15 April 2022

PROJECT: Hyla Crossing Pumped Stormwater Discharge Project, Issaquah, Washington

SUBJECT: Response to Comments

Exhibit D-2 – Tibbetts Creek Trail

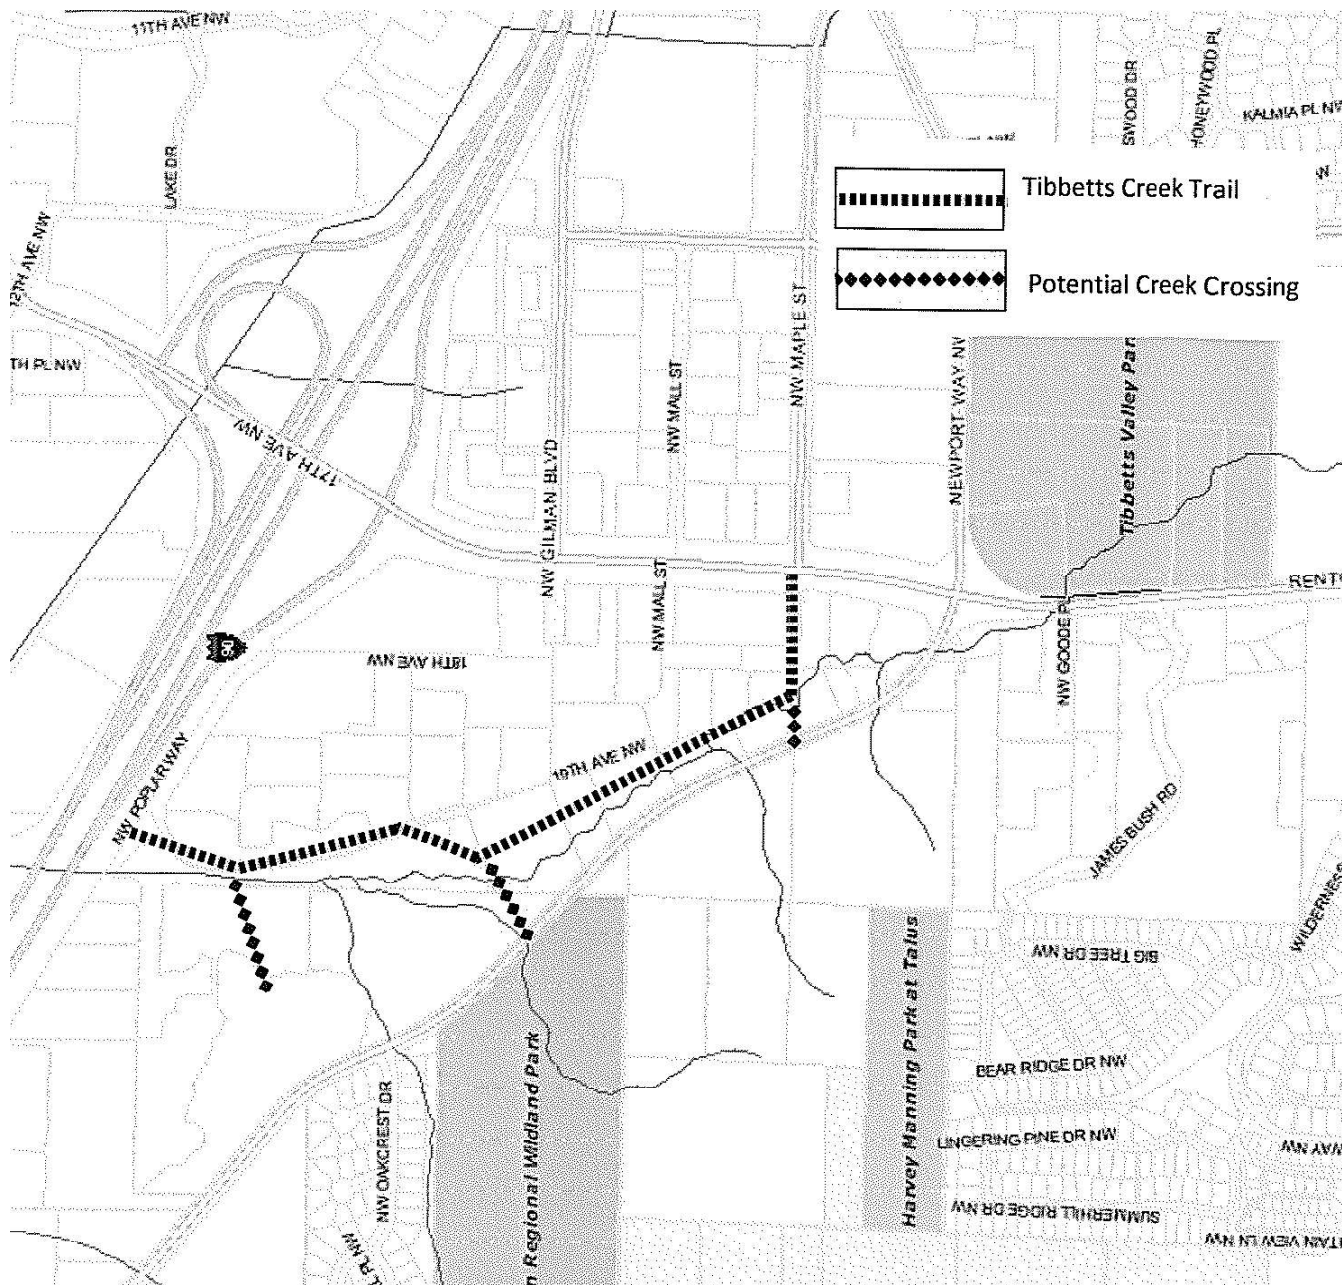
10. Provide additional buffer or mitigation for the proposed trail in the Tibbetts Creek buffer.

11. Remove the proposed trail from the Northern Enhancement Area square footage calculations. Additional buffer restoration may be required to maintain consistency with the Development Agreement Appendix J 7.0.B.1.b.3.

No additional buffer replacement or mitigation will be provided for the proposed trail within the Tibbetts Creek buffer because this trail is designed and located consistent with the DA. See response below for Recommendation #11 for more details.

The proposed trail at the outer edge of the Tibbetts Creek buffer restoration is consistent with the DA that specifies that some trails are required to be located within the critical areas buffers as part of the commitment to expanded pedestrian circulation around and through the Hyla Crossing neighborhood and as referenced by the City’s parks and open space strategic plan for circulation. The DA clearly identified this segment of trail along Tibbetts Creek. Additional buffer restoration is not proposed to compensate for buffer contained within this pedestrian trail.
